STAFF REPORT
COMMUNITY DEVELOPMENT DEPARTMENT

SUBJECT: H-2020-0005
 Landing South – RZ, PP

LOCATION: 660 S. Linder Rd. (Parcel #S1213233965; NW ¼ of Section 13, T.3N., R.1W.)

B. Preliminary Plat (date: 5/20/2020)

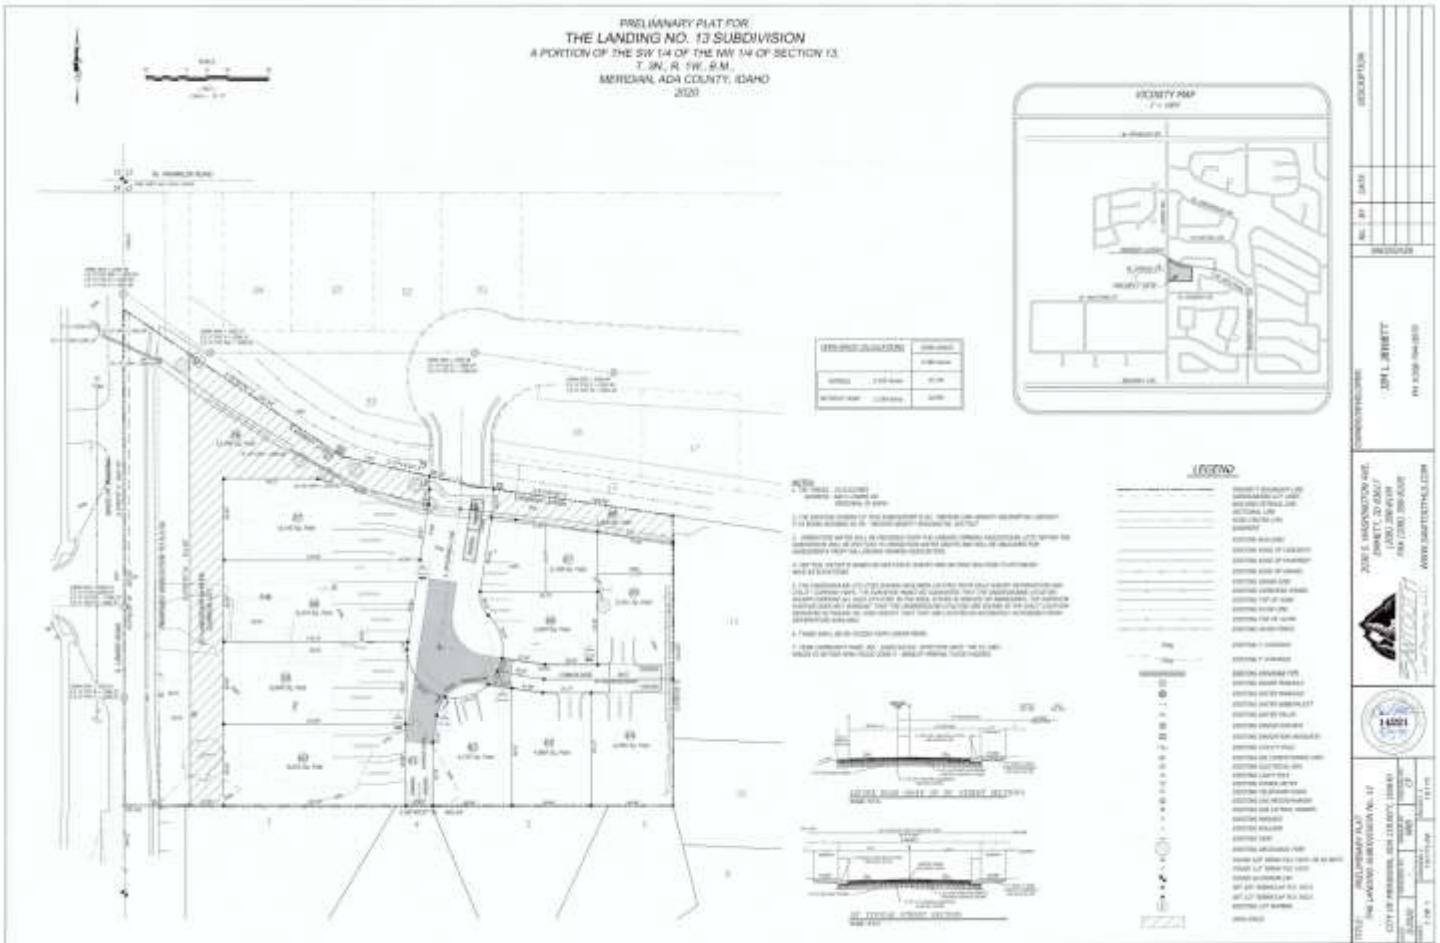
There are two (2) common driveways proposed; such driveways should be constructed in accord with the standards listed in UDC 11-6C-3D. **The common driveway that provides access to Lots 63-65 should be placed in a common lot. An exhibit should be submitted with the final plat application that depicts the setbacks, fencing, building envelope, and orientation of the lots and structures accessed via the common driveway; if a property abuts a common driveway but has the required minimum street frontage and is taking access via the public street, the driveway should be depicted on the opposite side of the shared property line from the common driveway. A perpetual ingress/egress easement is required to be filed with the Ada County Recorder, which should include a requirement for maintenance of a paved surface capable of supporting fire vehicles and equipment as set forth in UDC 11-6C-3D; a copy of the recorded easement should be submitted to the Planning Division with the final plat for City Engineer signature.**

A parking plan was included on the plat that depicts a total of two (2) on-street parking spaces available after driveways are provided for each lot (see Section VIII.B). Another four (4) spaces are provided at the end of each of the common driveways (2 at the end of each driveway). **Staff is concerned there may not be adequate on-street parking for guests; however, there is no**

The Kennedy Lateral runs along the northern boundary of this site and has been piped. The Irrigation District (NMID) has a 55' wide total easement in this area for the lateral, 20' from the centerline on this site. Any encroachments in this easement will require a signed License Agreement and approved plan prior to construction. **If the easement encroaches on adjacent buildable lots more than 10', the easement area should be included in a common lot that is a minimum of 20' wide and outside of a fenced area, unless modified by City Council at a public hearing with notice to surrounding property owners per UDC 11-3A-6E. The location of the easement should be clearly depicted on the plat.**

- ~~2. The final plat shall include the following revisions:~~
 - ~~a. Include a note prohibiting direct lot access via S. Linder Rd.~~
 - ~~b. The common driveway that provides access to Lots 63-65 shall be depicted in a common lot.~~

- ~~c. The easement for the Kennedy Lateral shall be clearly depicted on the plat; if the easement encroaches onto adjacent buildable lots more than 10 feet in width, the easement area shall be included in a common lot that is a minimum of 20 feet wide and outside of a fenced area, unless modified by City Council at a public hearing with notice to surrounding property owners as set forth in UDC 11-3A-6E.~~

C. Landscape Plan (date: 5/29/2020)

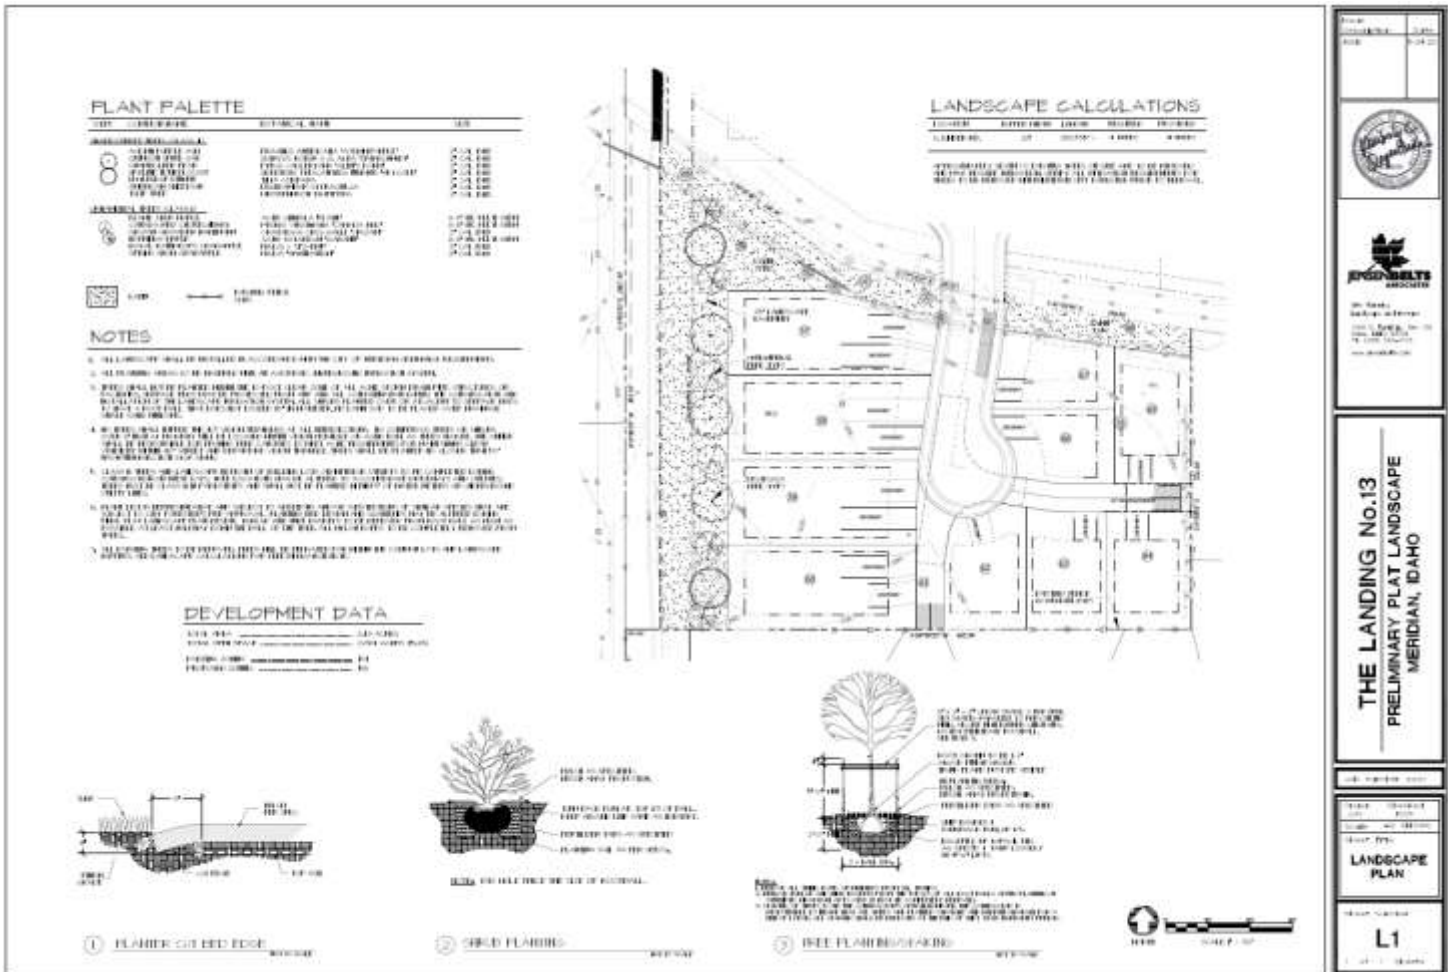
A 25-foot wide street buffer (measured from back of sidewalk) is required adjacent to N. Linder Rd., an arterial street, landscaped per the standards listed in [UDC 11-3B-7C](#), which require buffers to be planted with a mix of trees and shrubs, lawn, or other vegetative groundcover. Just lawn and trees are proposed; **Staff recommends shrubs are added at a minimum.**

There are several existing trees on this site that are proposed to be removed with development that require mitigation per the standards listed in UDC 11-3B-10C.5. The City Arborist inspected the site and determined an additional 67 caliper inches of trees need to be provided on the site for mitigation. The 50-inch caliper silver maple along Linder Rd. is required to be retained on the site and protected during construction, unless required to be removed by ACHD. Mitigation calculations should be included in the Landscape Calculations table demonstrating compliance with the aforementioned UDC standard.

All fencing is required to comply with the standards listed in UDC 11-3A-7. Fencing exists along the south and east boundaries of the site that is proposed to remain. No new fencing is proposed on the landscape plan. **Fencing is required to be constructed by the Developer adjacent to common open space lots to distinguish common from private areas as set forth in UDC 11-3A-7A.7a. The Applicant states that wrought iron fencing will be constructed at the back edge of the street buffer along Linder Rd. and along the Kennedy Lateral easement at the north boundary of the site; fencing should be depicted on the landscape plan accordingly.**

- ~~3. The landscape plan included in Section VIII.A.3, dated 5/29/2020, shall be revised as follows prior to submittal of the final plat application:~~

- ~~a. Depict wrought iron fencing as proposed by the Applicant along common open space lots to distinguish common from private areas in accord with UDC 11-3A-7A.7a.~~

- ~~b. Depict an additional 67 caliper inches of trees within common areas on the site as mitigation for removal of existing trees in accord with the standards listed in UDC 11-3B-10C.5. The 50 inch caliper silver maple along Linder Rd. is required to be retained on the site and protected during construction, unless required to be removed by ACHD.~~

- ~~c. Include mitigation calculations in the Landscape Calculations table based on the City Arborist's inspection, in accord with the standards listed in UDC 11-3B-10C.5; a total of 67 caliper inches of trees is required for mitigation.~~

- ~~d. Depict shrubs within the street buffer as set forth in UDC 11-3B-7C.3a.~~
- ~~4. Future development shall be consistent with the minimum dimensional standards listed in [UDC Table 11-2A-6](#) for the R-8 zoning district.~~

E. Conceptual Building Elevations

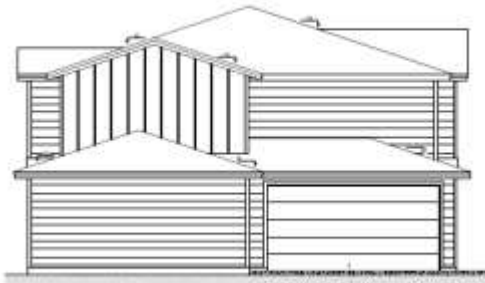
Duplex dwellings are 2-stories in height and constructed of a mix of vertical and horizontal siding. The rear/east street-facing elevations do not have any windows. **The proposed elevations are not approved with this application; final design is required to comply with the design standards listed in the Architectural Standards Manual. An application for Design Review should be submitted and approved by the Planning Division prior to submittal of applications for building permits for the duplex dwellings.**

- ~~b. The two family duplex dwellings are required to comply with the design standards listed in the Architectural Standards Manual. An application for administrative Design Review shall be submitted and approved by the Planning Division prior to submittal of applications for building permits for these units. *Single family detached dwellings are exempt from design review.*~~
